Panel Report

**Hobsons Bay Planning Scheme Amendment C88
'Precinct 15' - Altona North**

22 February 2018

Plan 3 - Altona North Local Town Centre Concept Plan

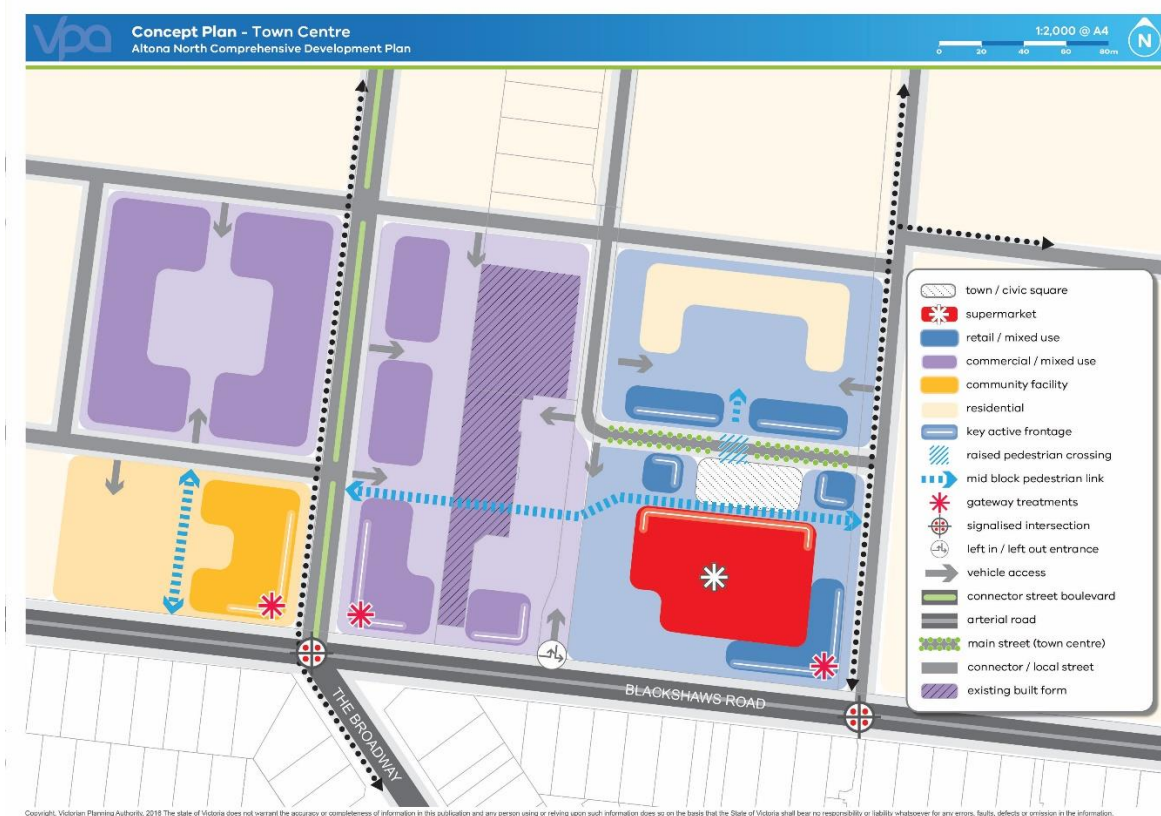
- b) Amend Plan 1 (Future Urban Structure) to add the gateway locations.**
 - c) Amend Plan 3 (Altona North Local Town Centre Concept Plan) by deleting the 'commercial/mixed use area' from Property 8 north of the community facility and consolidating it with the internal residential sub-precinct.**

Figure 10 - Blackshaws Road Interface

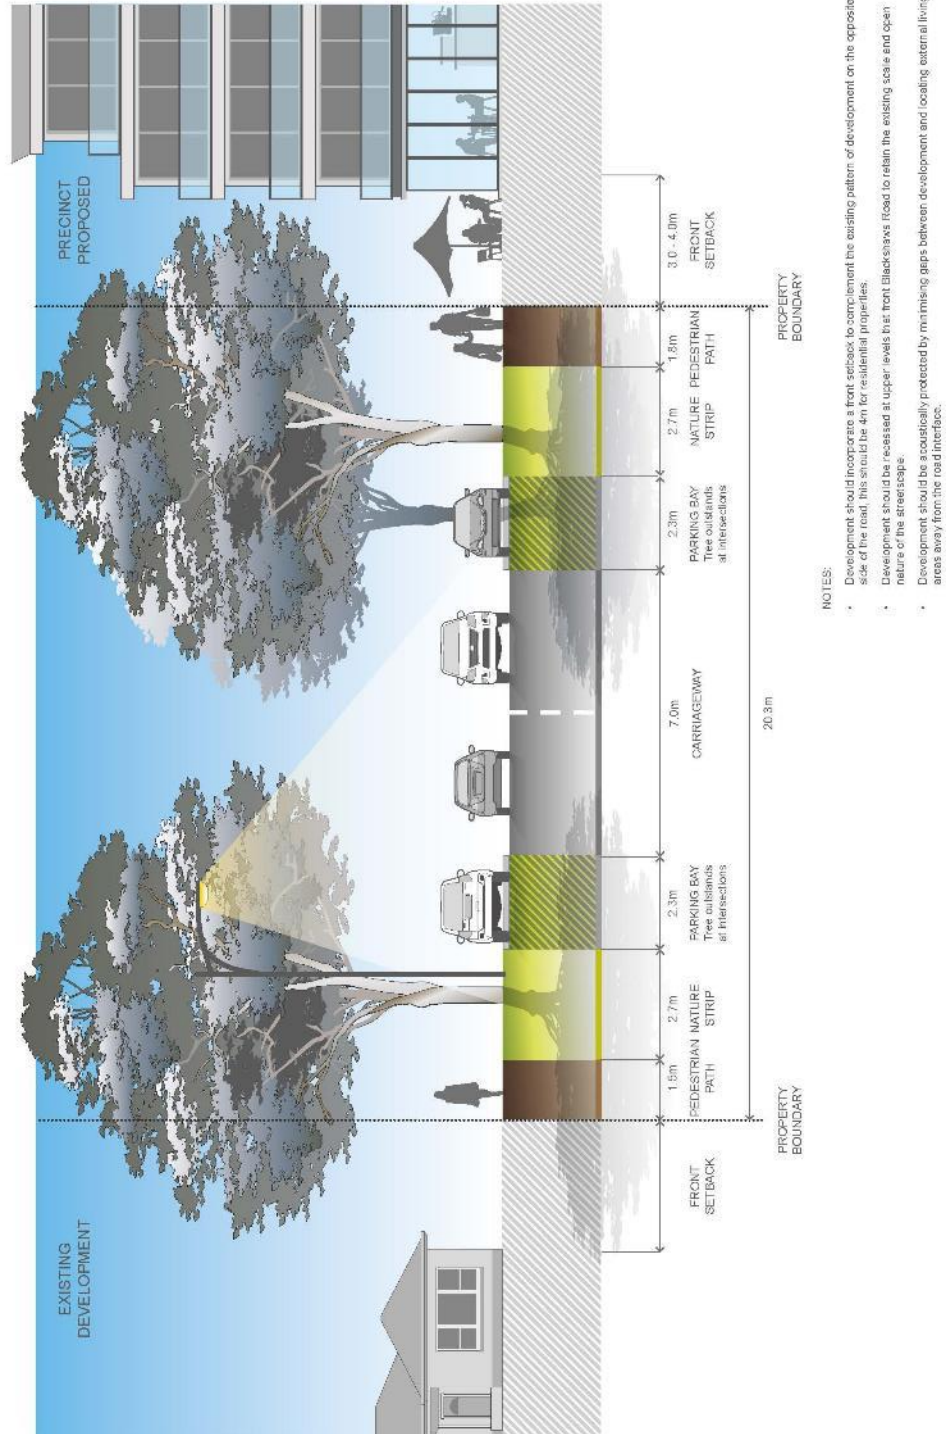
- Amend Figure 1 (Blackshaws Road interface) to show an on-road bike lane to be consistent with other plans.

Amend Figure 1 (Blackshaws Road Interface) to show an on-road bike lane.
